## **ADDENDUM TO THE CONTRACT**

### **JNU FIRE ALARM UPGRADE Contract No. BE21-159**

**ADDENDUM NO.: FIVE**

INFORMATIONAL  
Existing Wireless Smoke Alarm System

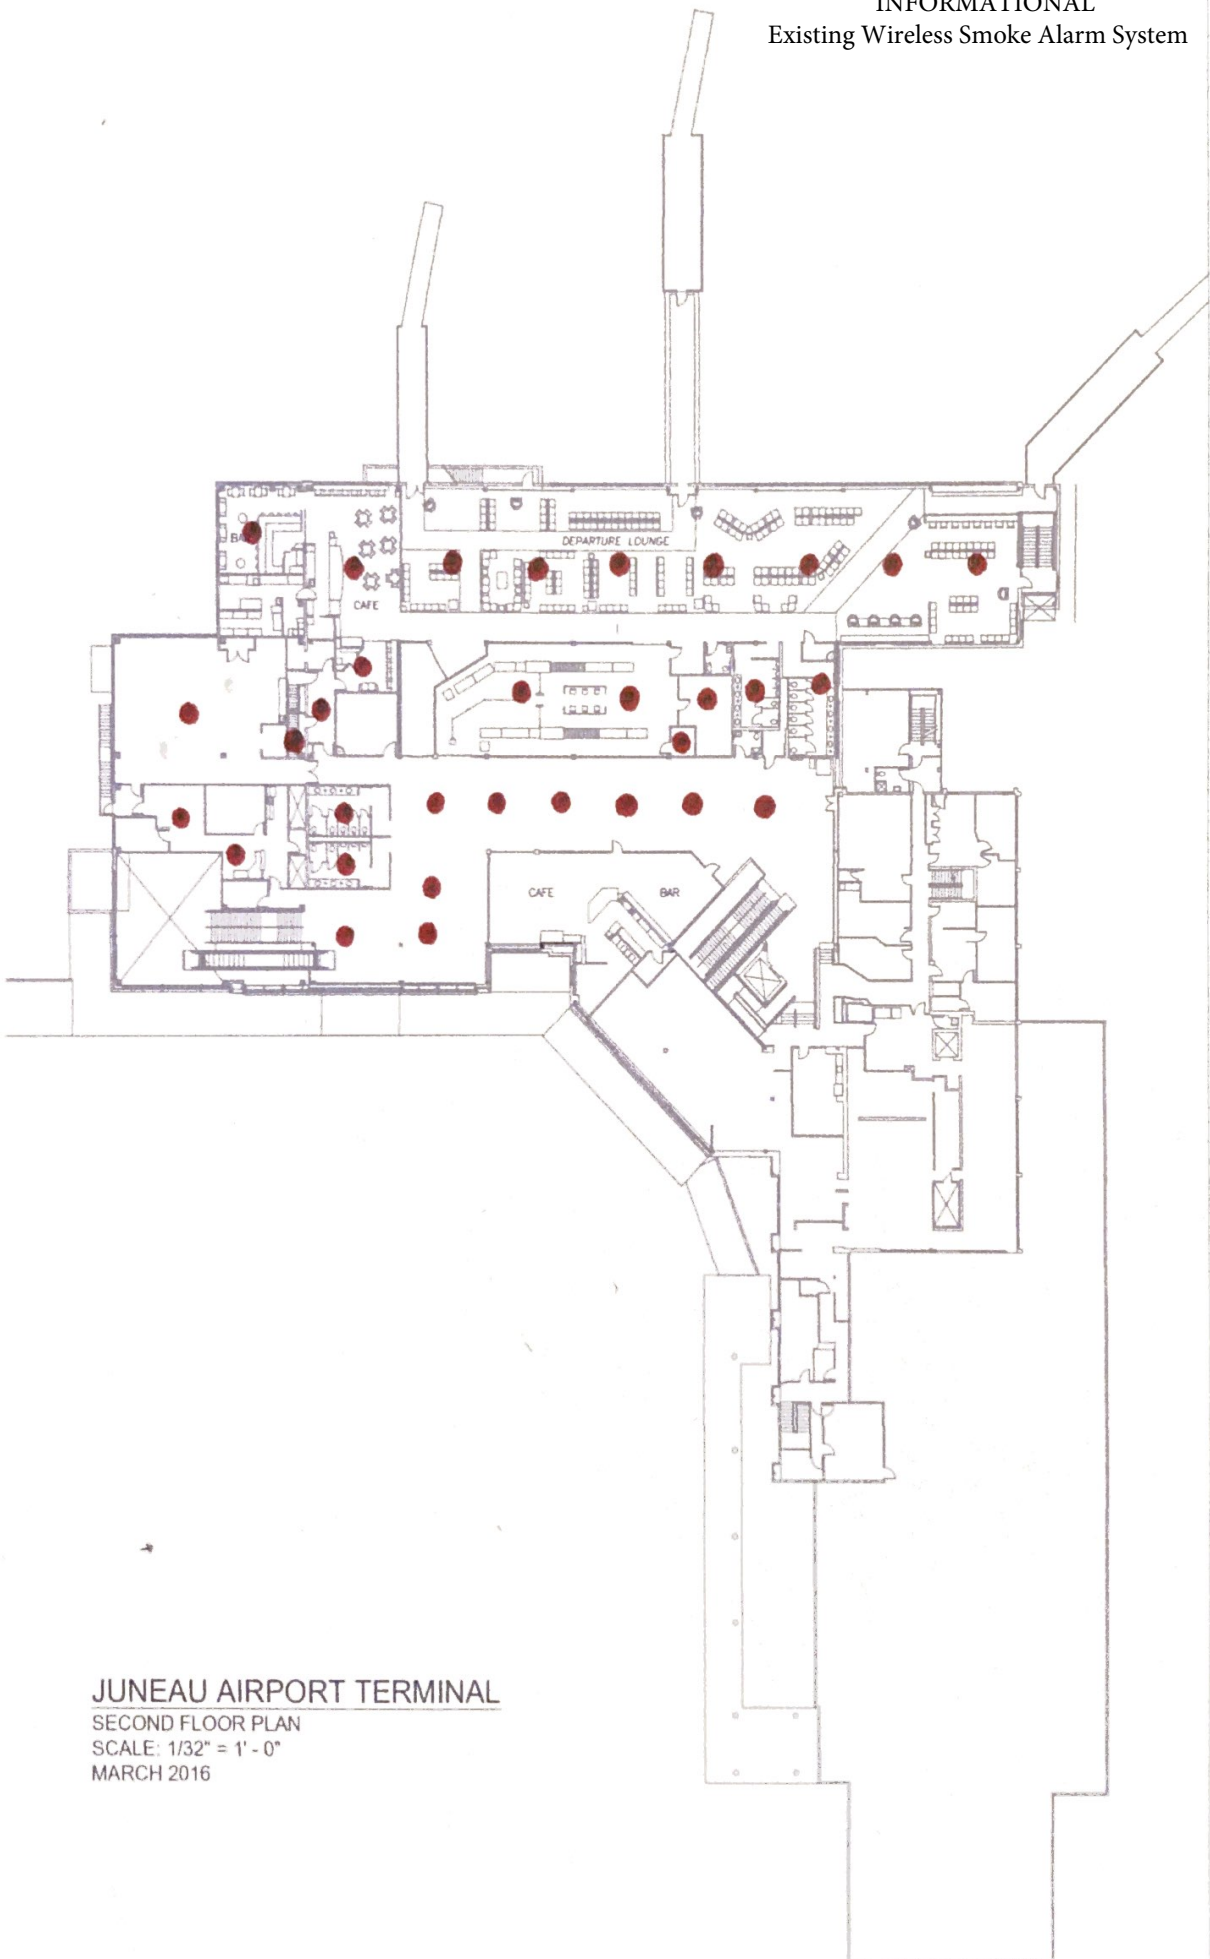
- The existing Silent Knight Fire Alarm system will be tested in its entirety on Friday March 19, 2021 as part of the Terminal Reconstruction project. Investigative efforts associated with this testing has generated an initial devices and circuits point list that has been attached to this ADDENDUM. Investigative efforts have also identified active stand-alone wireless smoke detectors (33 total) that have been installed in portions of the second floor of the terminal, including the second floor Departure Lounge, the second floor TSA Passenger Screening areas, and the second floor Electrical Room. These wireless smoke detectors are part of a stand-alone fire detection and alarm system that was installed independently of the terminal fire alarm system to meet evacuation and security requirements within the Departure Lounge area. This stand-alone system has been interconnected to access control devices on Gates 2 thru 6 and on the bypass hallway door, and has the ability to alert LJ Alarm. A second floor plan which shows where the wireless detectors have been installed has been attached to this ADDENDUM.

- As part of the JNU Fire Alarm Upgrade Project, remove all of the existing second floor stand-alone fire detection and alarm system including, but not limited to, the wireless smoke detectors and notification devices, and replace these devices with wired addressable devices that are to be incorporated into the fire alarm system that is to be installed under the new JNU Fire Alarm Upgrade project. The existing interconnections to the existing access control devices are to be maintained and integrated into the final fire alarm installation. Conduit and conductors required for this work is to be installed per the requirements of the JNU Fire Alarm Upgrade project.

- As part of the JNU Fire Alarm Upgrade Project, furnish and install addressable fire alarm detection devices where required by code. Furnish and install additional addressable devices within the second floor of the terminal as outlined within ADDENDUM 5 and incorporate them into the new fire alarm system. Reference attached Sketch map of the existing wireless smoke alarm system.
